ORIGINATION FORM

Proposed Revisions to a Standard Plans Index
(Please provide all information — Incomplete forms will be returned)

Index Number: 649-020
Sheet Number (s): All Sheets
Index Title: Steel CCTV Pole

ASSEMBLY

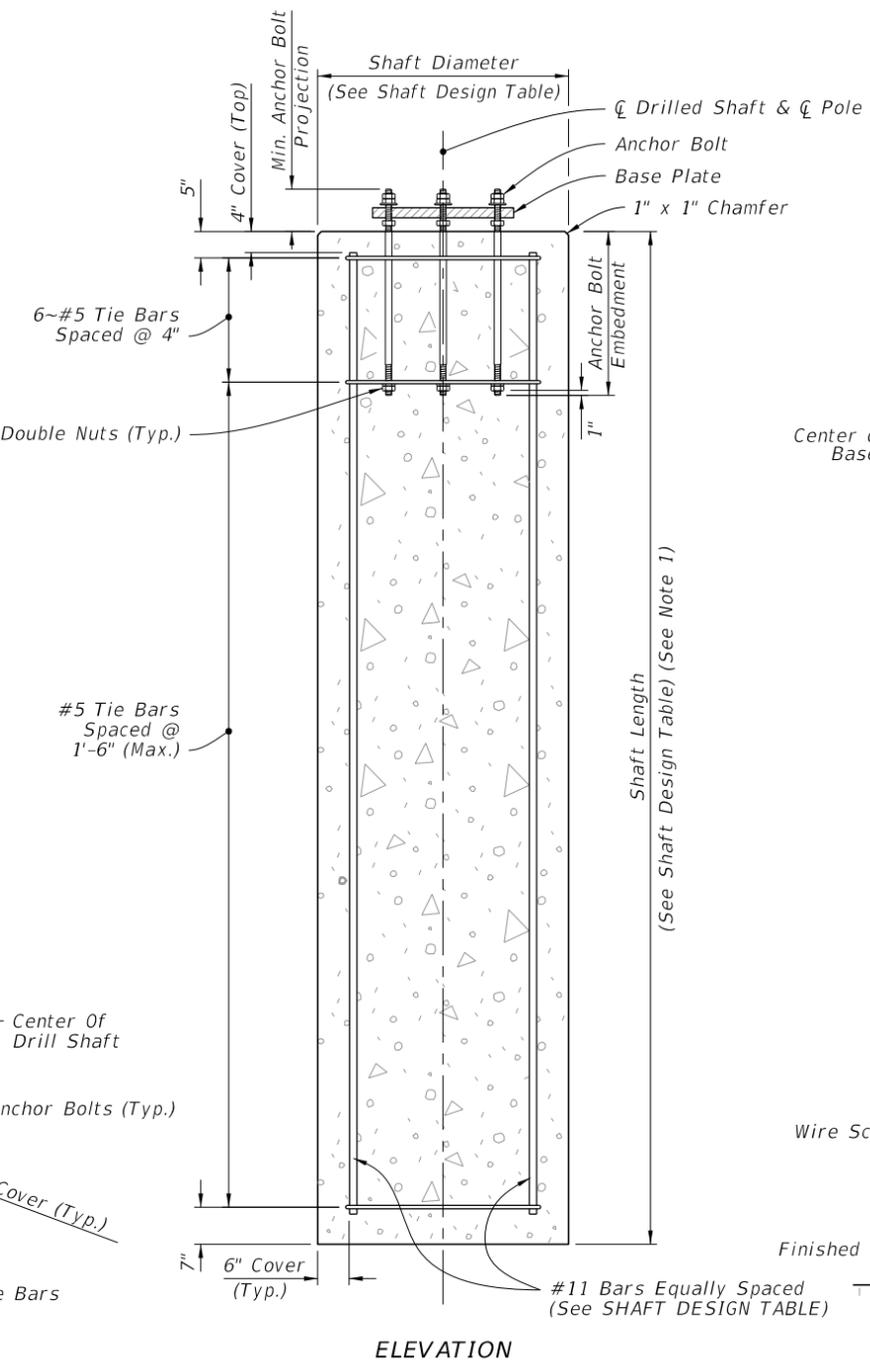
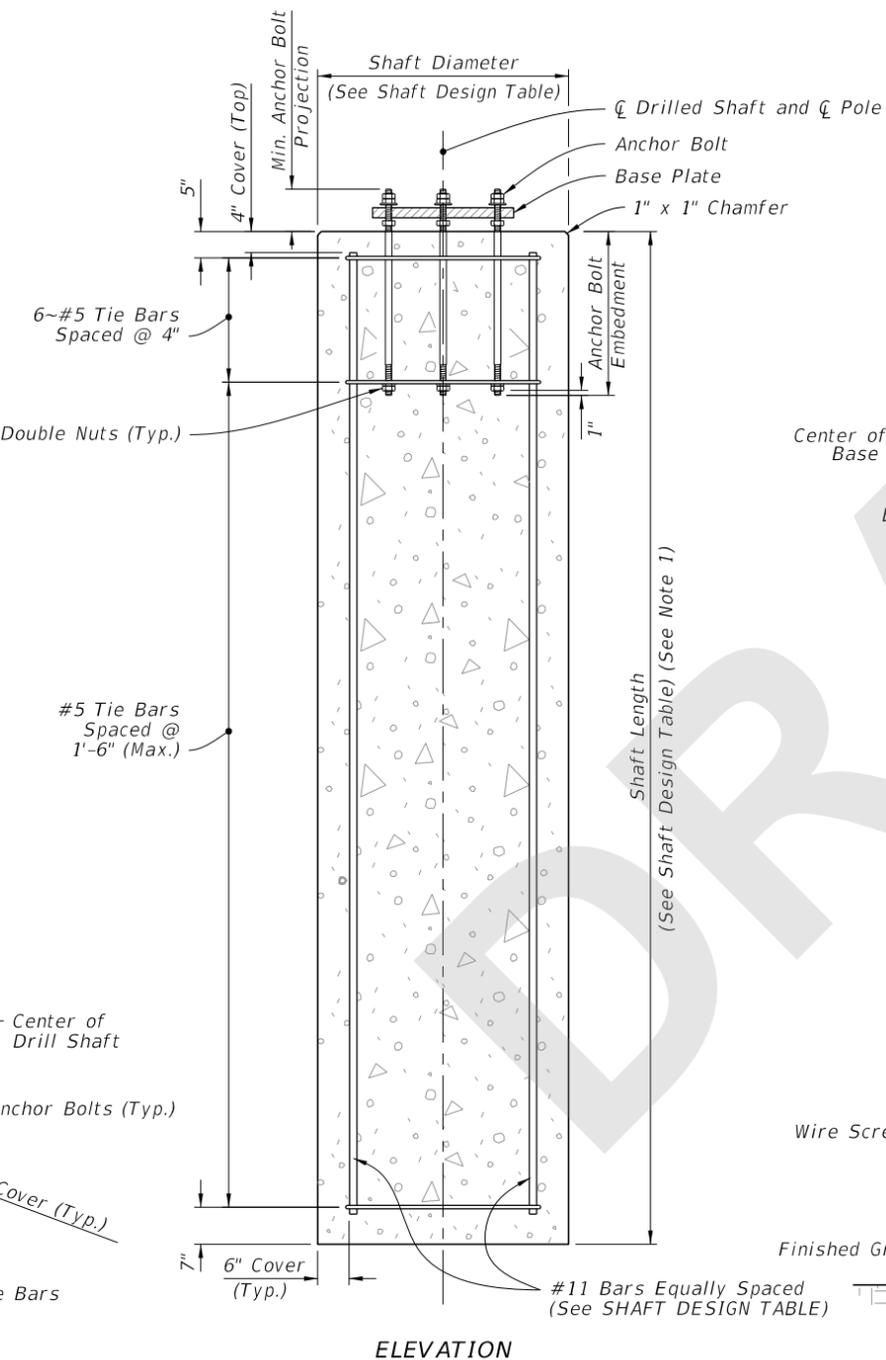
Updated Detail to match Sheet 1

ASSEMBLY

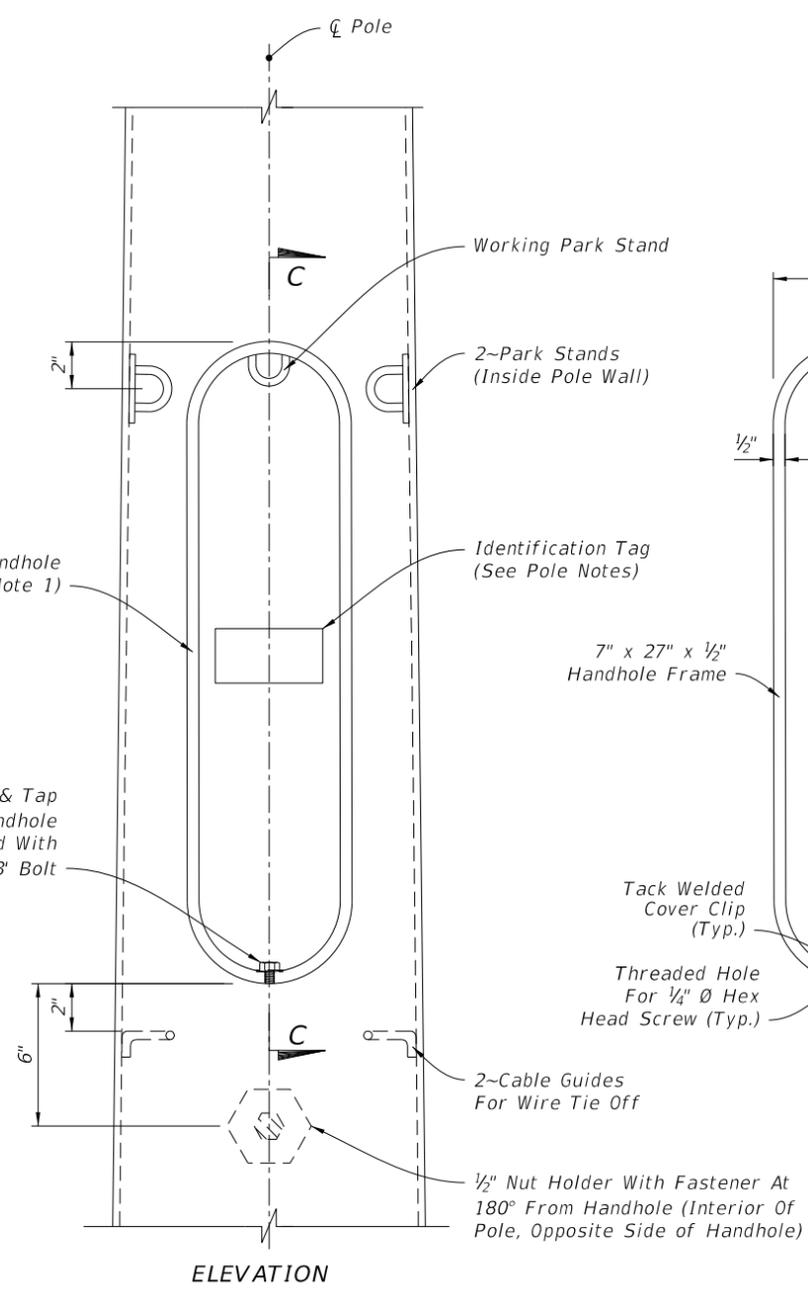
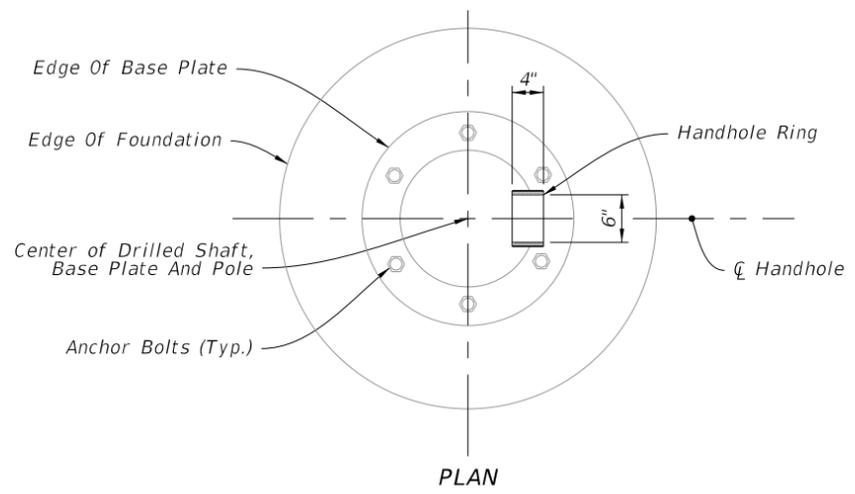
Updated Detail to match Sheet 1

ASSEMBLY

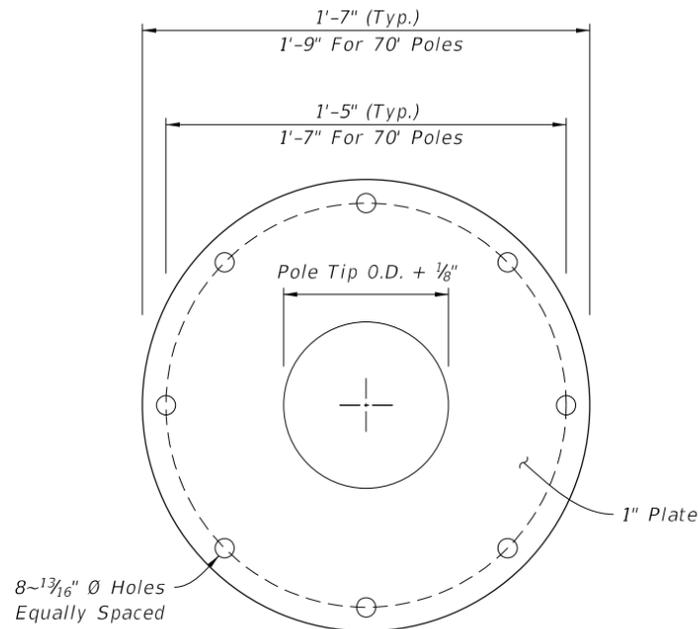
Updated Detail to match Sheet 1

DETAIL "E"

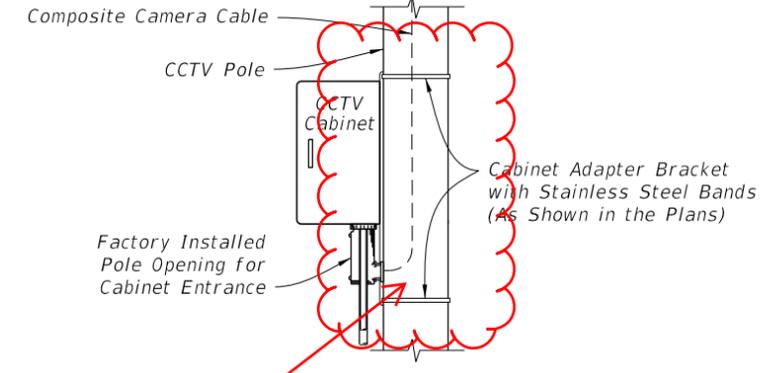
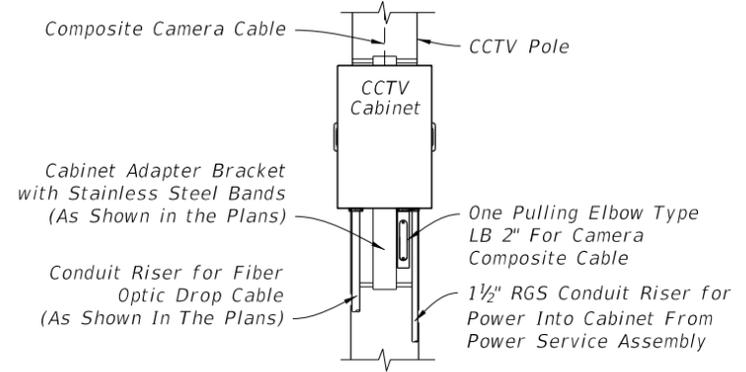
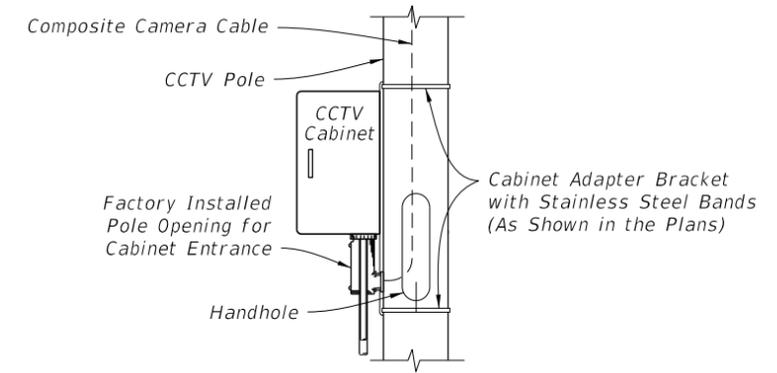
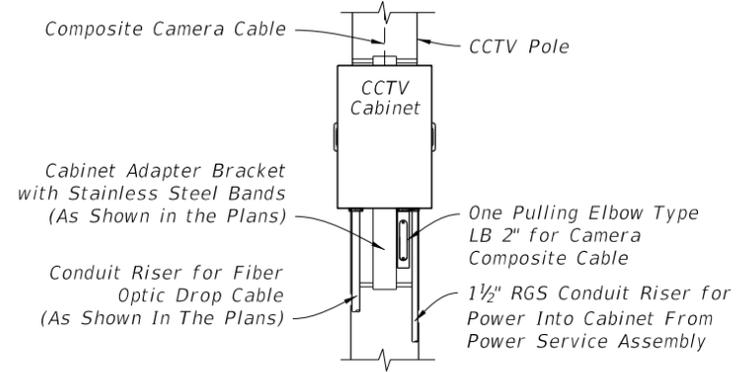
The handhole should be located downstream of the traffic so all details and notes will be updated for the proper representation. Also added notes to make Index consistent with Standard Plans Index 641-020.

Added: Handhole SIDE VIEW
